CITY OF SAN ANTONIO

Re: Los Caminos

POADP # 704

LOS CAMINOS
 PRELIMINARY OVERALL DEVELOPMENT PLAN

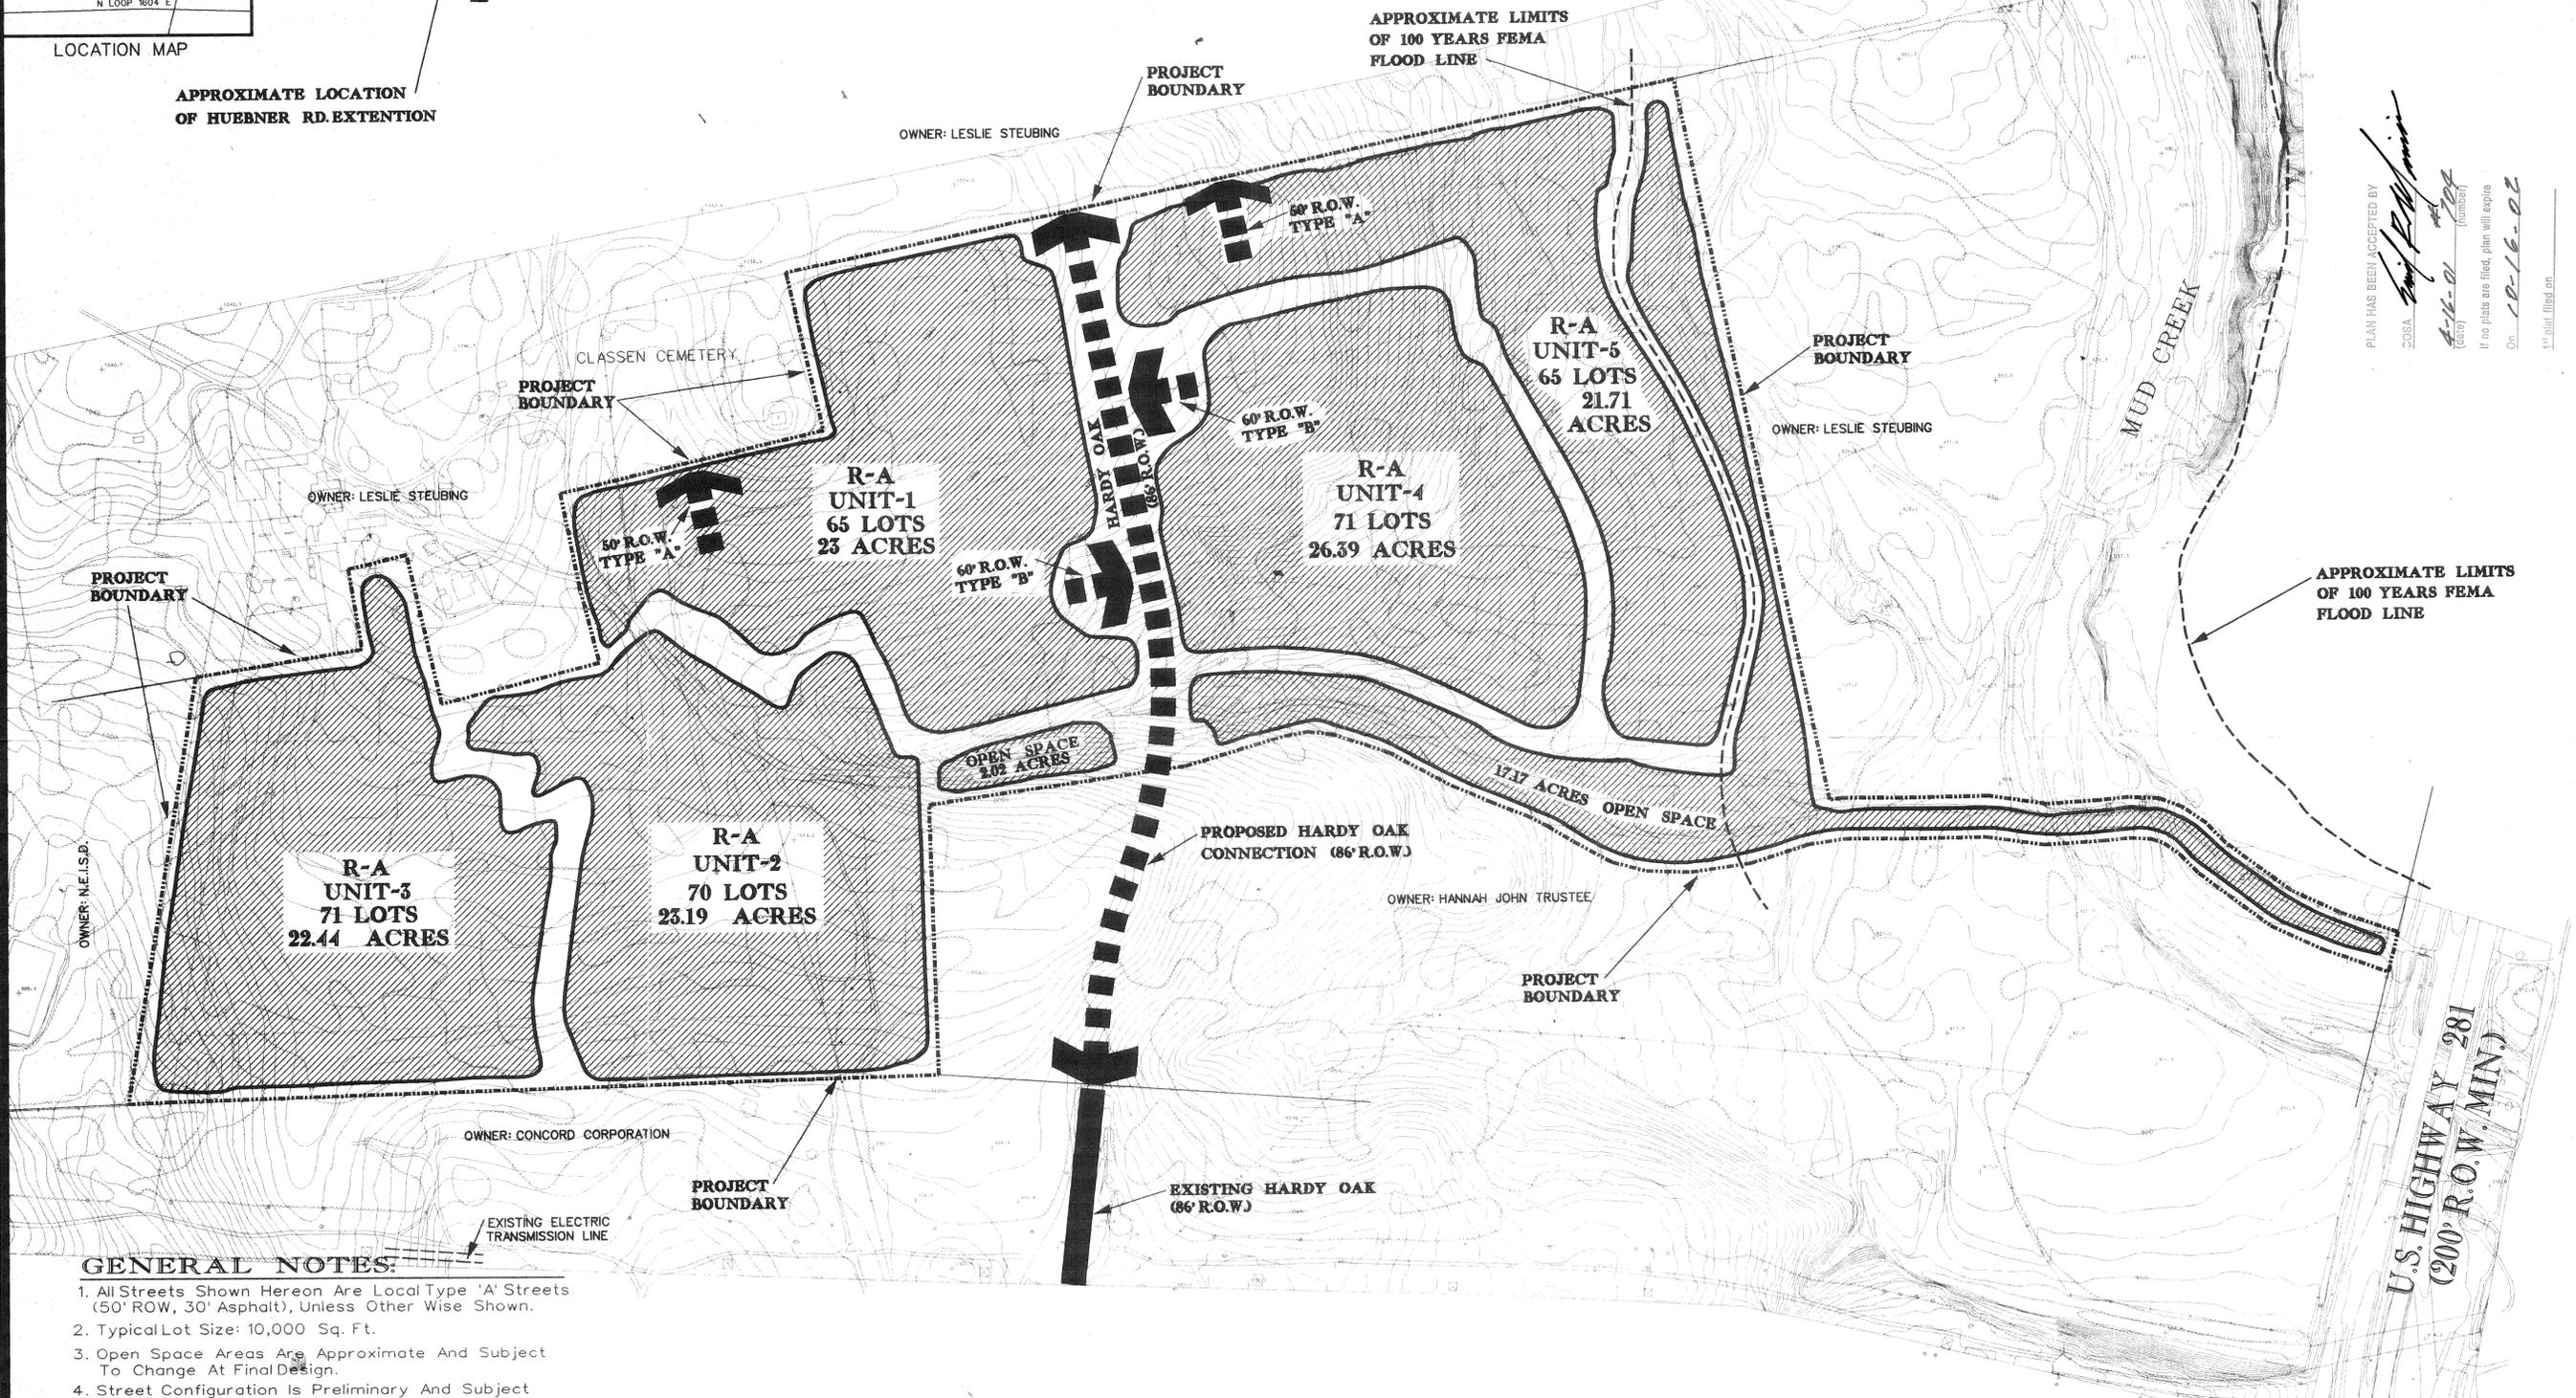
The City Staff Development Review Committee has reviewed Los Caminos Subdivision Preliminary Overall Area Development Plan # 704. Please find enclosed a signed copy for your files. Your plan was accepted however please note the following:

- In consideration of public safety and convenience, excessive grades by reason of topography should be avoided in street layouts and arrangements.
- Access and R.O.W. issues along state facilities will need to be resolved with the Texas Department of Transportation (TXDOT). For information about these requirements you can contact TXDOT at 615-5814.
- This development will need to comply with tree preservation ordinance #85262. For information about these requirements you can contact Building Inspections at 207-7102.
- It will be expected that you will plat all of the property depicted in your POADP, to include: floodplains, drainage areas and open space.
- I would encourage you to work closely with the school district, so that they can plan accordingly.

(a) Huebner Rd is on the Major Thoroughfare with a proposed 86' R.O.W. The northern edge of this site needs to show half of the required R.O.W (43').

(a) Hardy Oaks Rd. and Huebner Rd. intersect at this site, both will have to be shown with the required 86' R.O.W.s.

d) Paragh, (2) The resulting additional ingress and egress of vehicles will seriously disrupt the flow of traffic on the thoroughfare. A 1'-non accesses esm't will be required on the properties adjacent to the proposed Major Thoroughfare.

3.) Redland Rd. is proposed by Tx-Dot to connect to Huebner Rd Please show this alignment and how it will affect the northern part of your property as per our discussion.

- (a) Huebner Rd R.O.W. needs to be shown on the proposed P.O.A.D.P.
- (c) City Arborist approval is missing.
- (d) Show current zoning on P.O.A.D.P.
- (i) One hundred-year floodplain limits was not identified on plan.

(a) It appears that Hardy Oaks Rd. and Huebner Rd. intersect at this site, both will have to be shown with the required 86' R.O.W.s.

d) Paragh, (2) The resulting additional ingress and egress of vehicles will seriously disrupt the flow of traffic on the thoroughfare. A 1'-non accesses esm't will be required on the properties adjacent to the proposed collectors.

3.) Access needs to be provided to the adjoining properties for connectivity.

4.) An approved T.I.A. will be required.
